**DOCUMENT 00 90 00**  
**ADDENDUM**

**ADDENDUM No.:** 1

**RE:** WESTERN TECHNICAL COLLEGE  
COLEMAN CENTER 2024 RENOVATION  
368 6TH ST NORTH  
LA CROSSE, WISCONSIN 54601  
PROJECT NO. 23072

**1** DEMO PLAN RM 111  
1/8" = 1'-0"

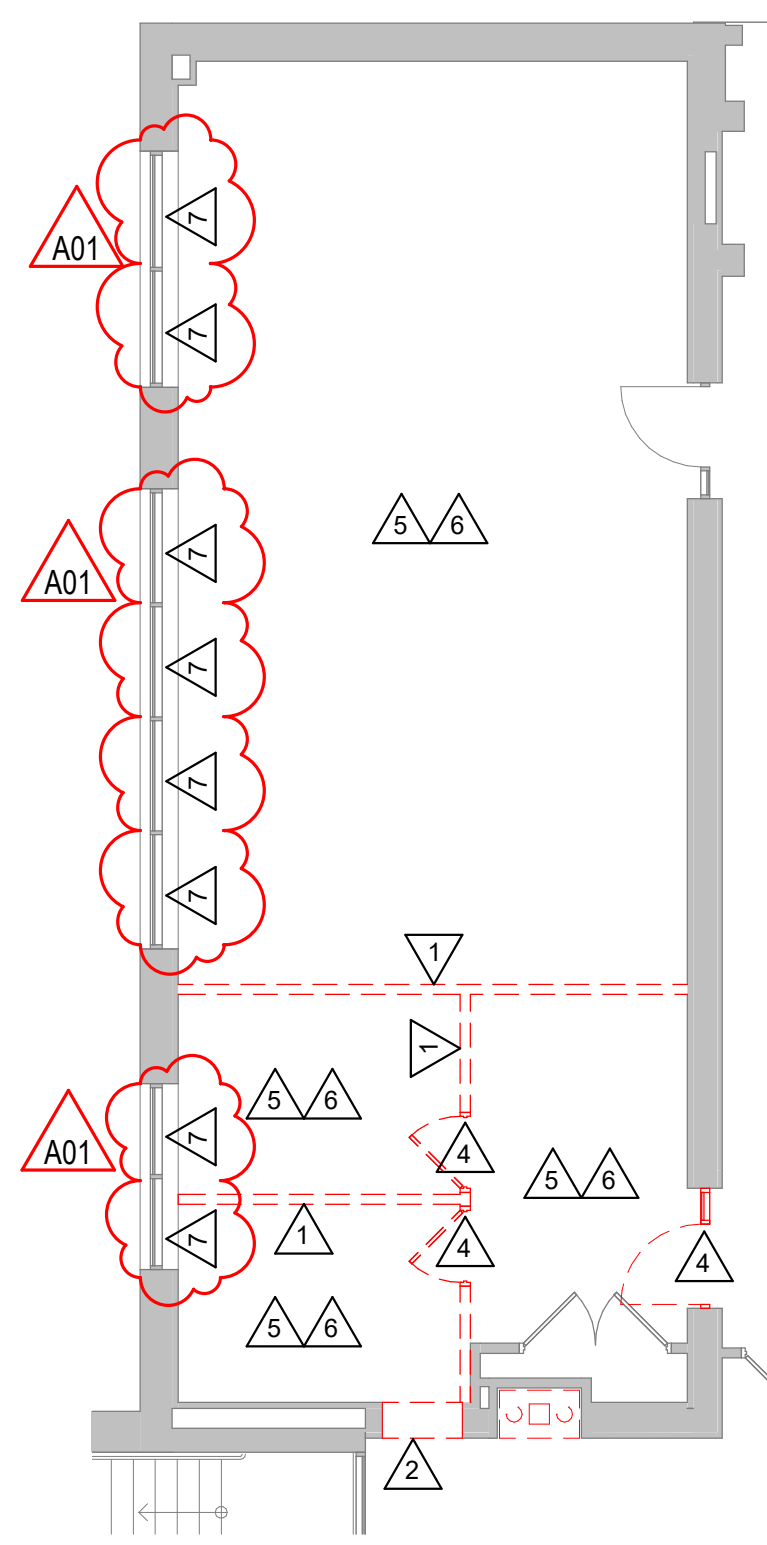
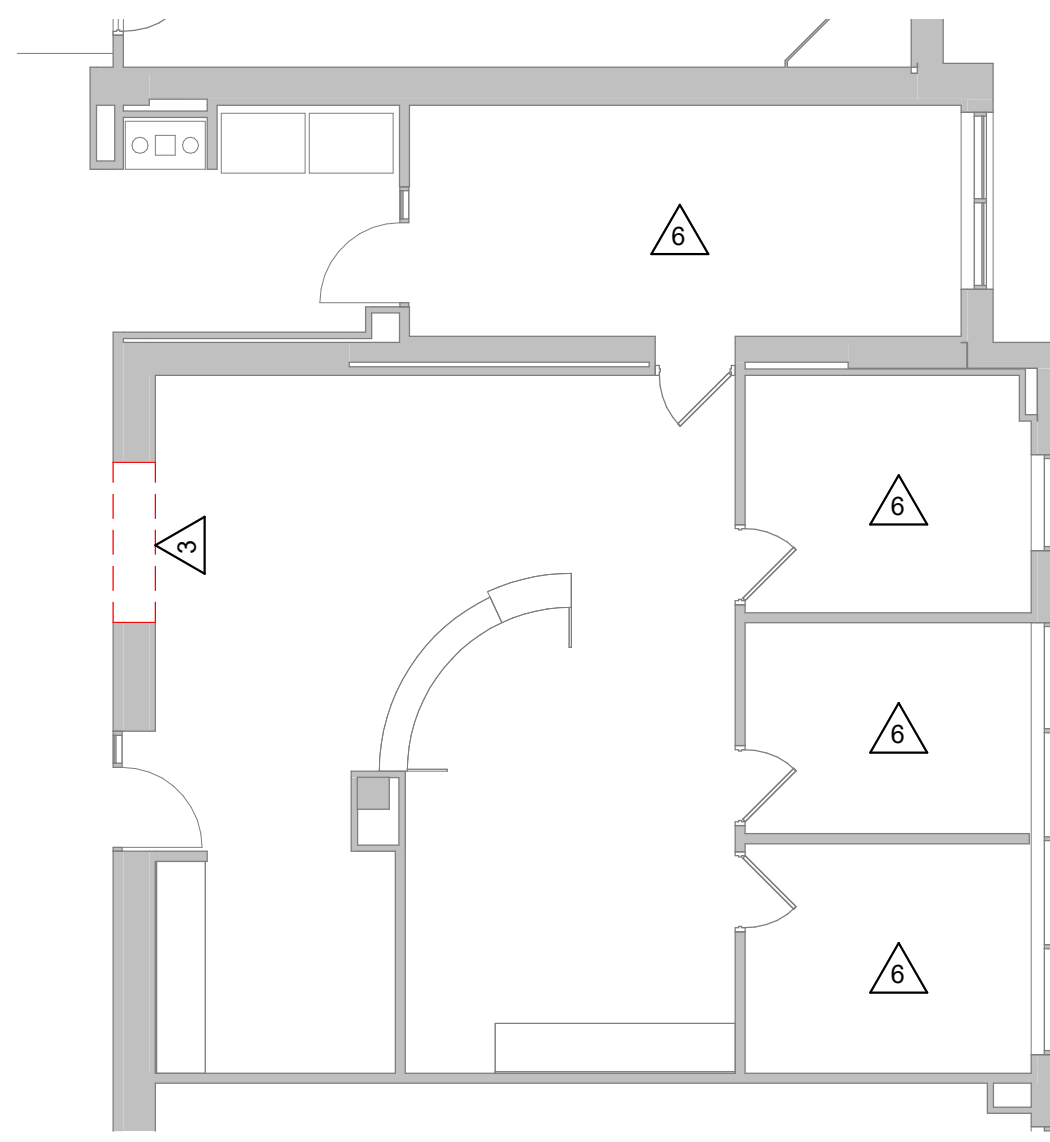
2. Sheet A090 REMOVAL PLANS 30"x42"
  - a. See the revised sheet included in this addendum. Disregard the previous version.
  - b. KEY NOTES REMOVAL: See clouded changes for keynote 7 added.

- c. 1/A090: See clouded changes for keynote 7 added.
3. Sheet A102 ENLARGED PLAN, RCP 30"x42"
  - a. See the revised sheet included in this addendum. Disregard the previous version.

- 1 REMOVE EXISTING STUD PARTITION AND GYP BOARD WALL FINISH
- 2 CREATE OPENING IN EXISTING MASONRY WALL FOR NEW DOOR/WINDOW. REMOVE MASONRY WALL TO FLOOR DECK ABOVE.
- 3 CREATE OPENING IN EXISTING MASONRY WALL FOR NEW DOOR/WINDOW OVERSIZED DEMOLISHED OPENING AS REQUIRED FOR INSTALLATION OF JAMB REINFORCING AND LINTEL.
- 4 REMOVE EXISTING DOOR AND FRAME, INCLUDING SIDELIGHT AND TRANSOM WINDOW WHERE APPLICABLE.
- 5 REMOVE EXISTING SUSPENDED ACOUSTIC TILE CEILING SYSTEM.
- 6 REMOVE EXISTING CARPET FLOORING AND VINYL BASE.
- 7 REMOVE EXISTING WINDOW SHADES.

**1** RCP RM 111  
1/8" = 1'-0"

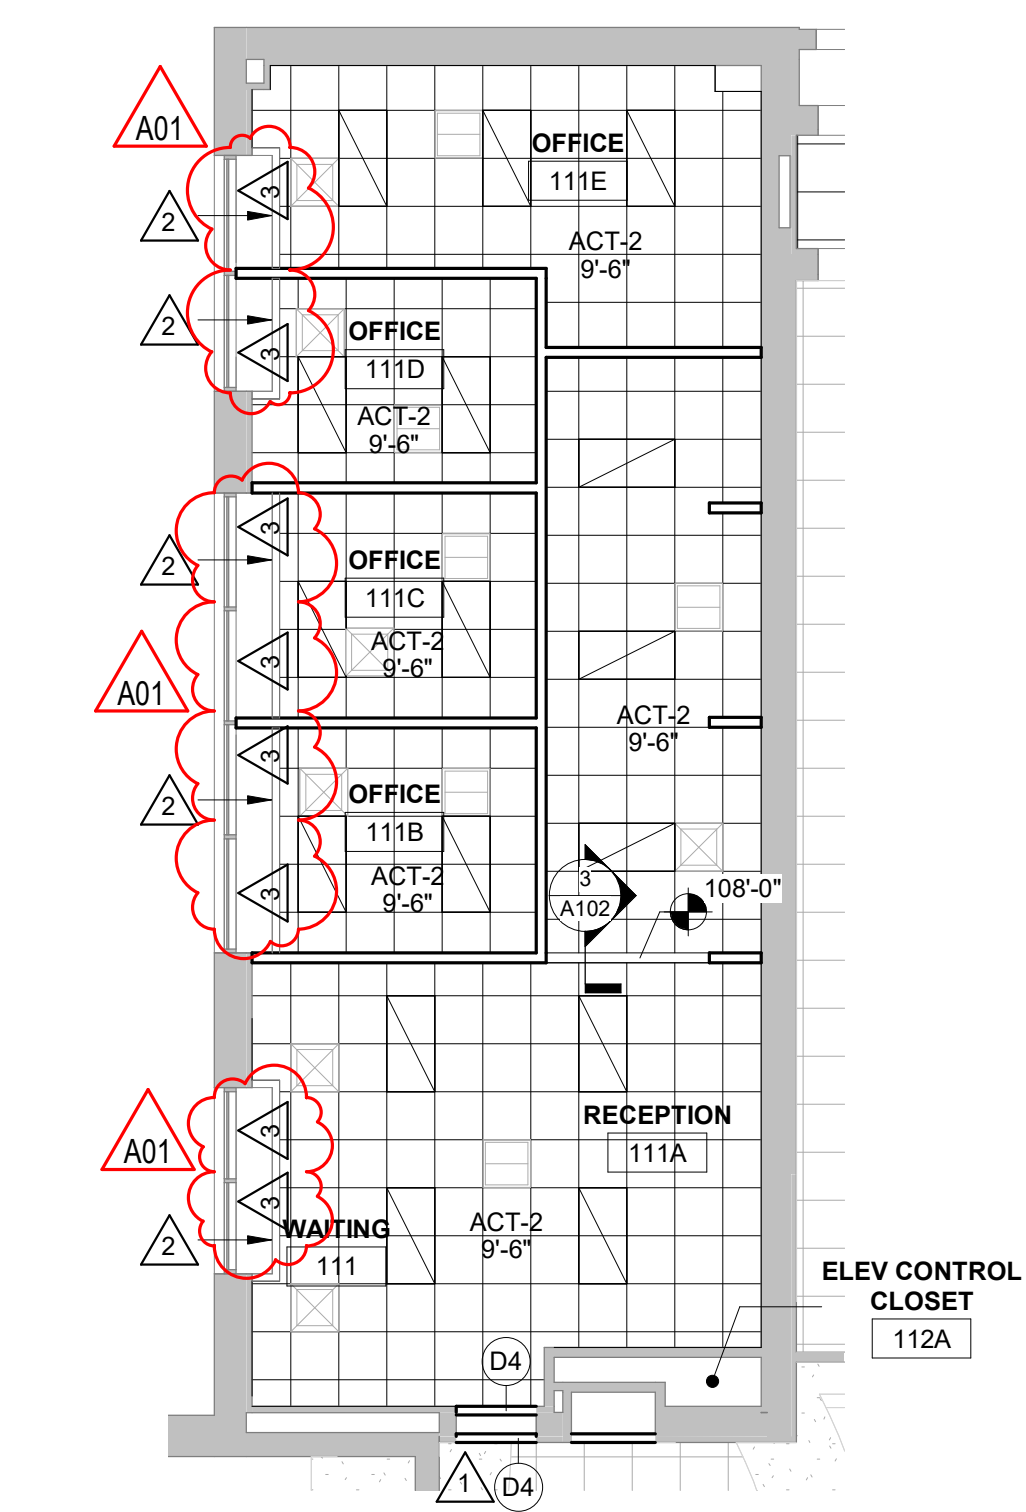
- b. KEY NOTES RCP: See clouded changes for keynote 3 added.
  - c. 1/A102: See clouded changes for keynote 3 added.
4. Sheet ID101 FINISH FLOOR PLAN 30"x42"

- 1 REMOVE/REINSTALL GYP CEILING AS REQUIRED FOR INSTALLATION OF NEW OPENING. HEADER AND REMOVAL OF EXISTING MASONRY WALL
- 2 REMOVE AND REINSTATE GYP WINDOW WEALS AS REQUIRED FOR INSTALLATION OF NEW WALLS AND AC TILE CEILING
- 3 WINDOW SHADE WS-1

**ID101**

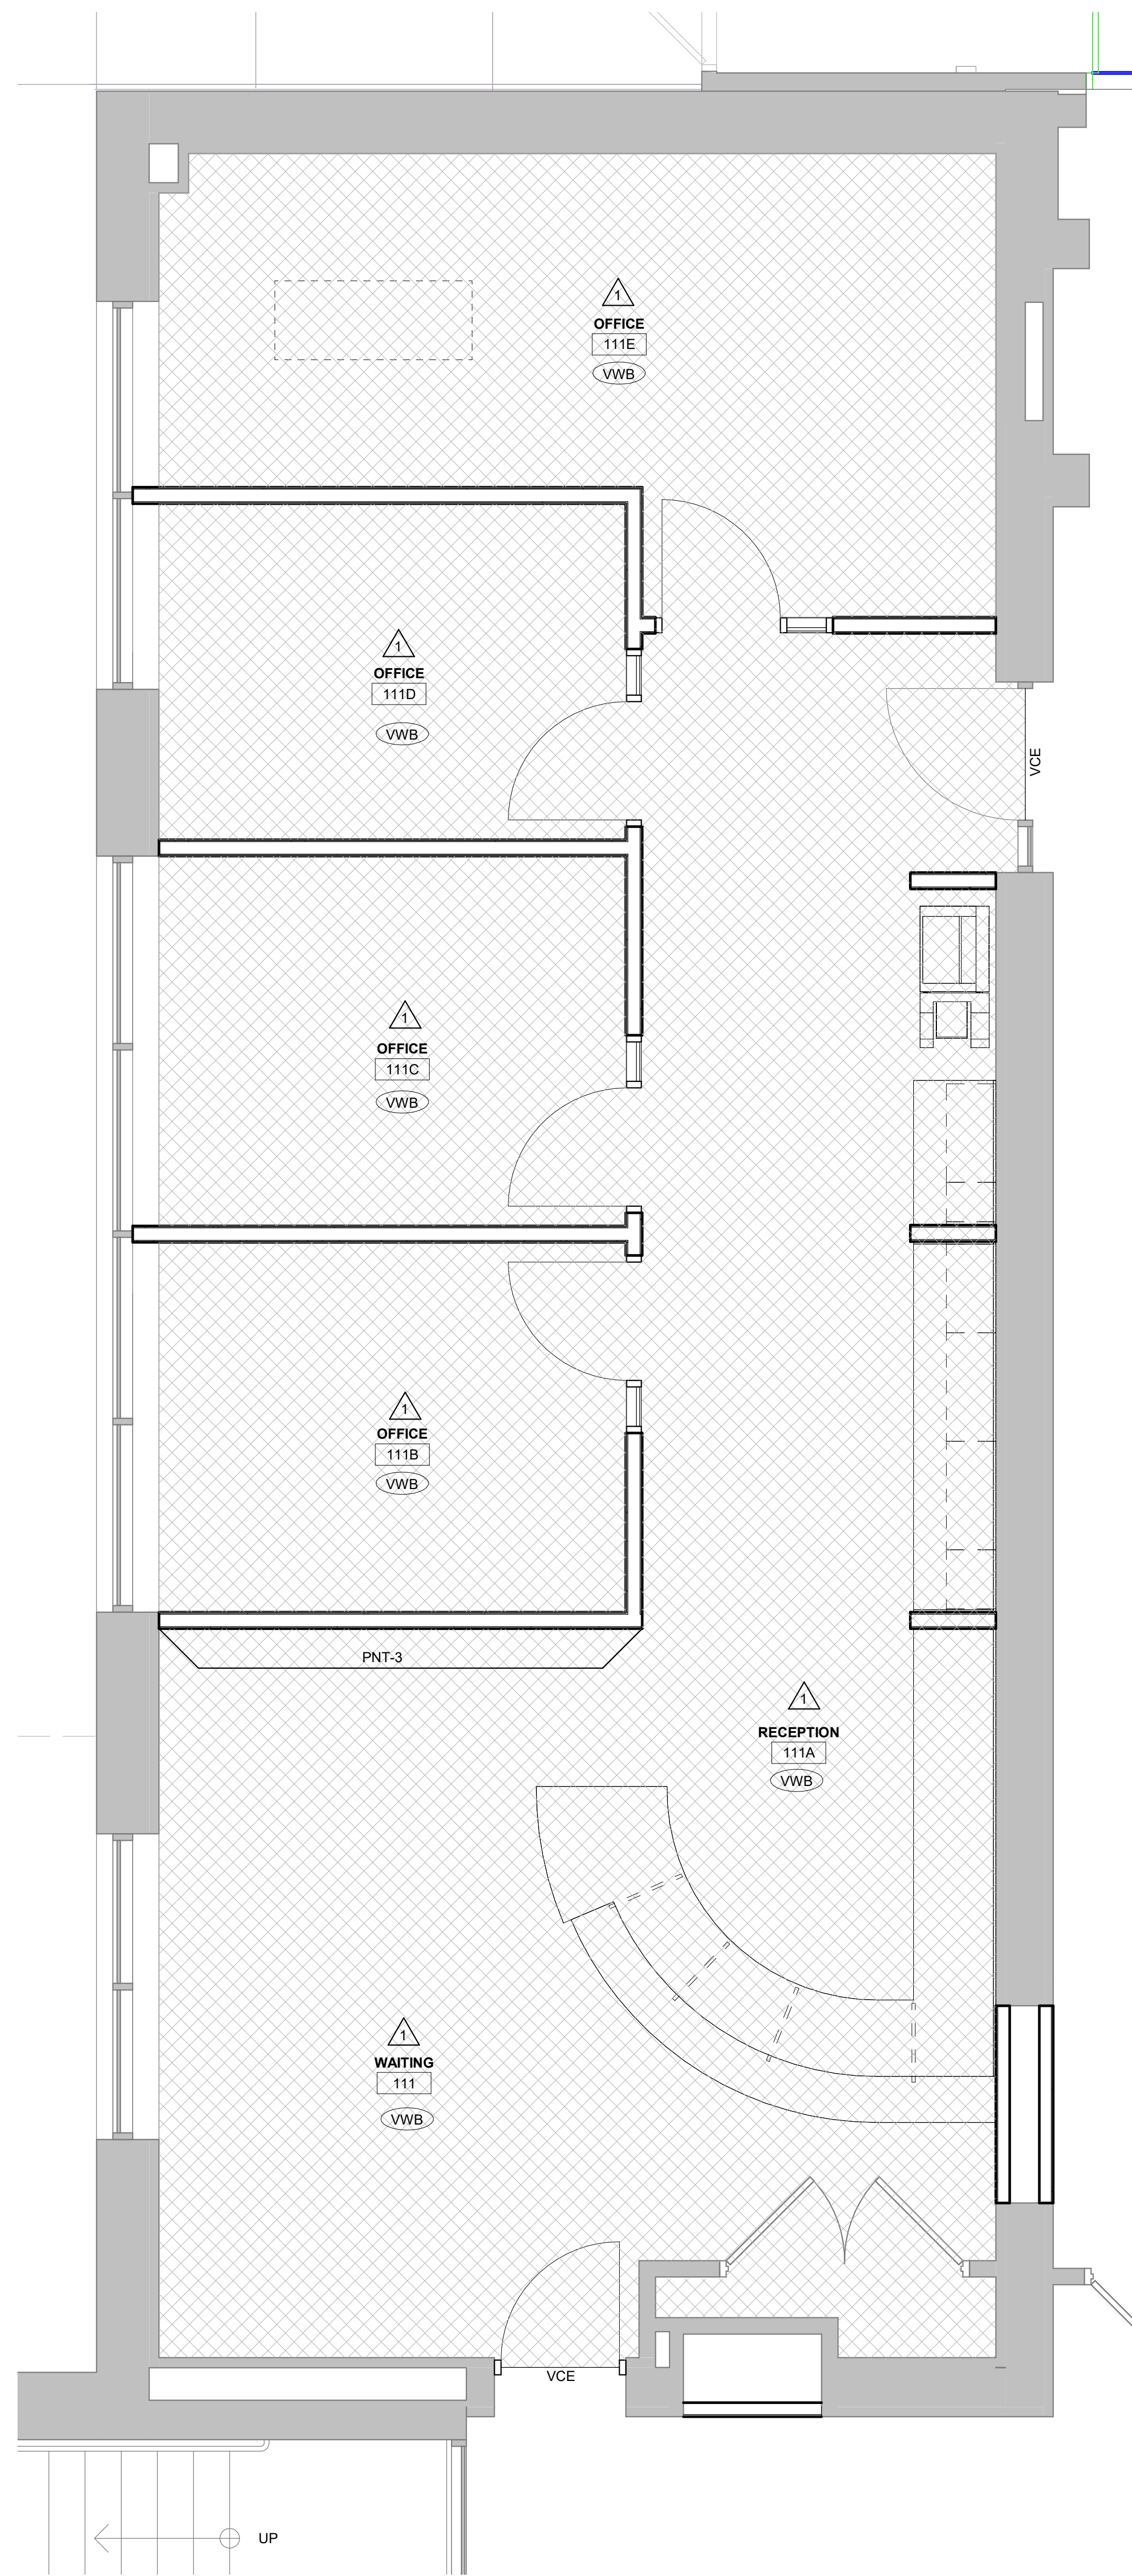
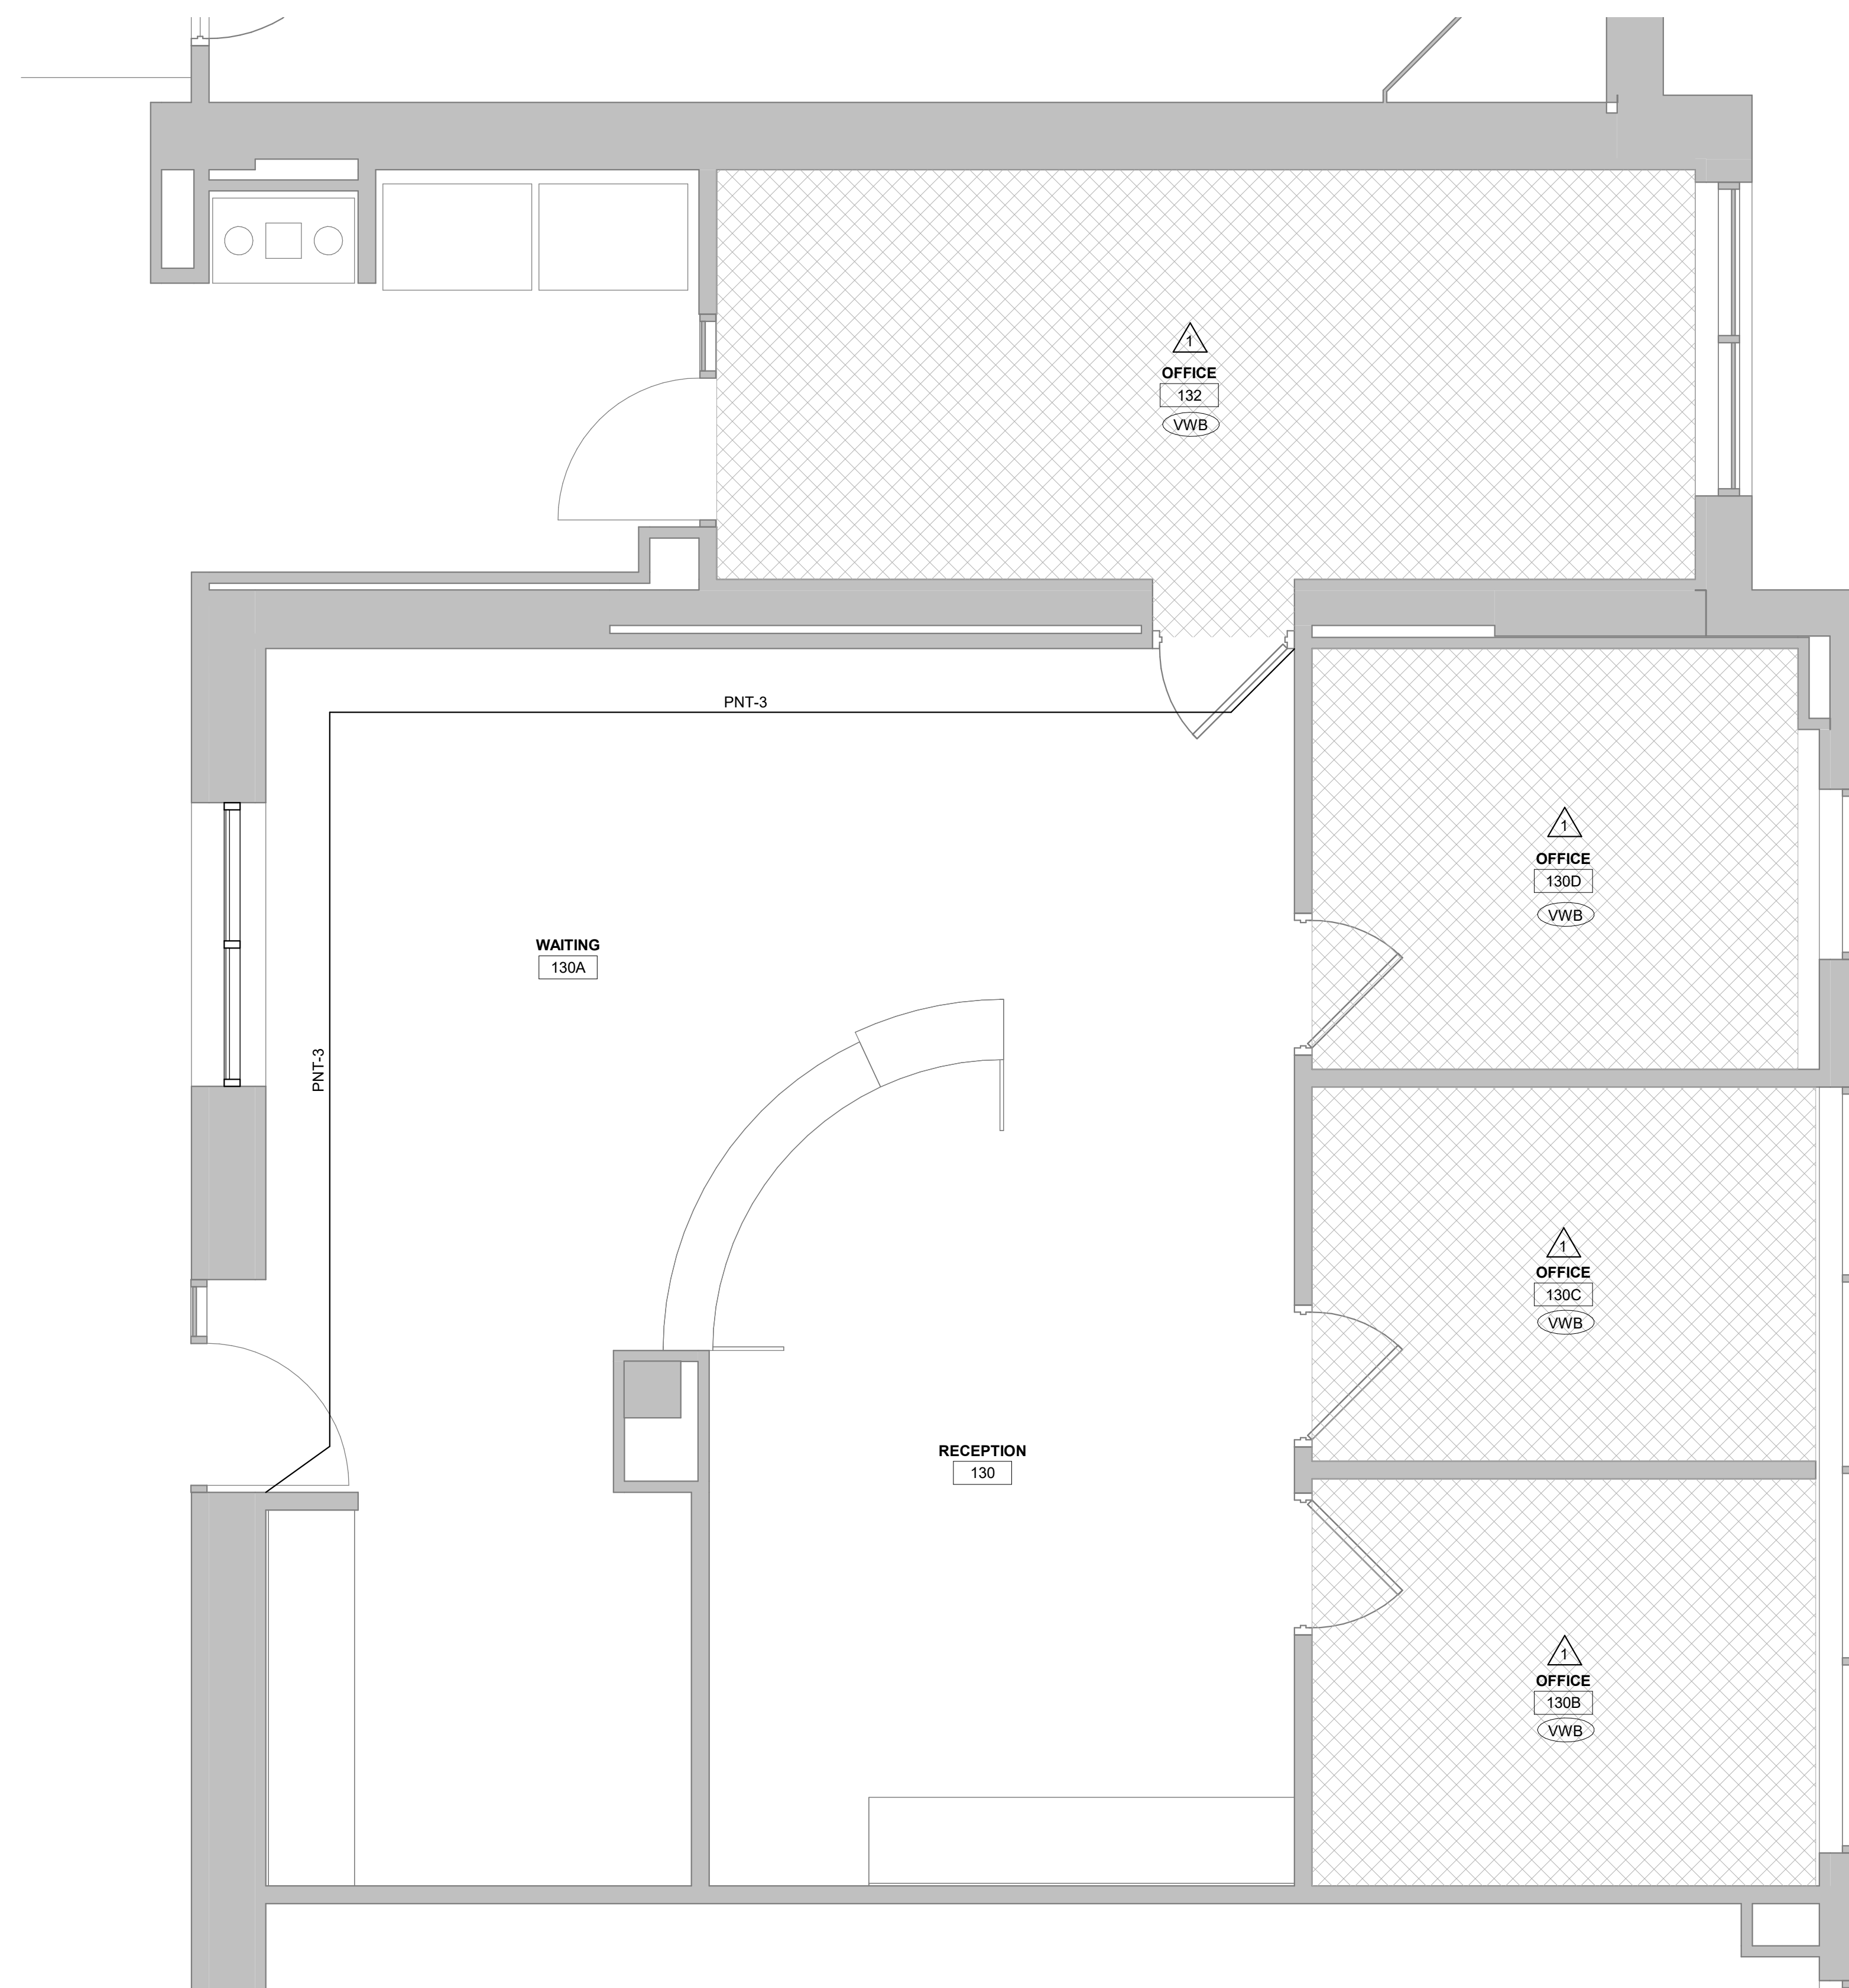
- a. See the revised sheet included in this addendum. Disregard the previous version.
  - b. MASTER COLOR SCHEDULE: See clouded changes for WS-1 added.
